SUBJECT: Application for amends to Licenses NPF-14 & NPF-22. Amends change Tech Specs re diesel generator testing w/one generator out of svc & circuitry & pumps associated w/ out-of-svc generators. Fee paid.

SUSQUEHANNA STEAM ELECTRIC STATION  
PROPOSED AMENDMENT NO. 58 TO NPF-14  
AND PROPOSED AMENDMENT NO. 13 TO NPF-22  
ER 100450 FILE 841-8  
PLA-2346

The purpose of this letter is to request a one time exemption to Technical Specifications 3.8.1.1 and 3.7.1.2 to allow Pennsylvania Power & Light Co. to remove the diesel generators one at a time from service for an accumulated time of 60 days. This exception is required in order to perform work on the connection of the control and power circuits to the new fifth diesel at Susquehanna SES. Attachment A shows the proposed wording for this exemption.

Figure 1: Event Tree for Loss of Offsite Power at SSES

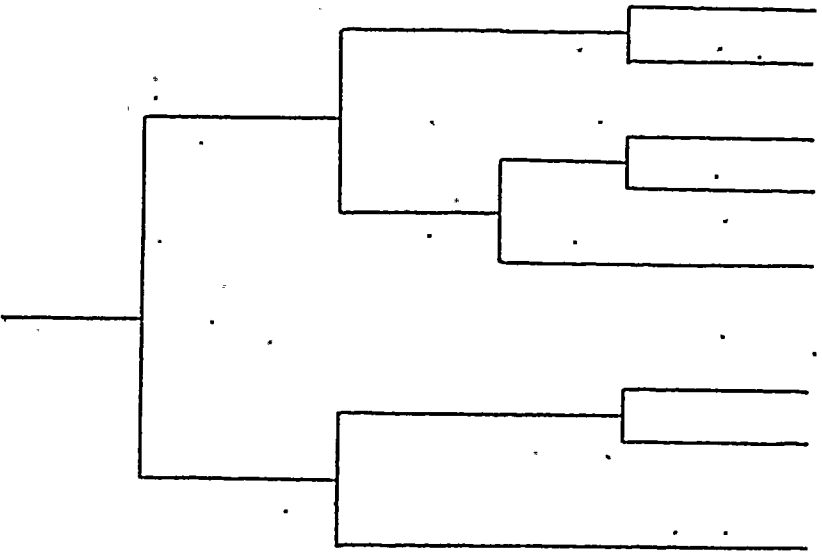
Sequences leading to inadequate core cooling are identified using the event tree illustrated in Figure 1. The LOOP frequency and system unavailabilities associated with the event tree heading are derived from data available in open literature. The LOOP frequency and system unavailabilities were combined using the event tree logic to obtain the yearly frequency of inadequate core cooling. This yearly frequency was calculated for two conditions: with all four diesel generators in standby, and with three in standby and one in a LCO. The frequency of inadequate core cooling (per year) is then calculated by summing these frequencies weighted by the yearly fraction of time in each condition. The equation for the frequency of inadequate core cooling is as follows:

The increased risk associated with continued operation of both units with a diesel generator inoperable for 3 days is acceptable. Arguments supporting this statement are found in the applicable Technical Specification Bases section and Regulatory Guide 1.93. In this evaluation risk is defined as the probability of inadequate core cooling during a LOOP. The proposed temporary change in the diesel generator LCO increases the frequency of LOOP sequences leading to inadequate core cooling from  $5.0 \times 10^{-6}$ /yr. to no more than  $6.4 \times 10^{-6}$ /yr. This represents a minimal impact when considering the uncertainties in the data.
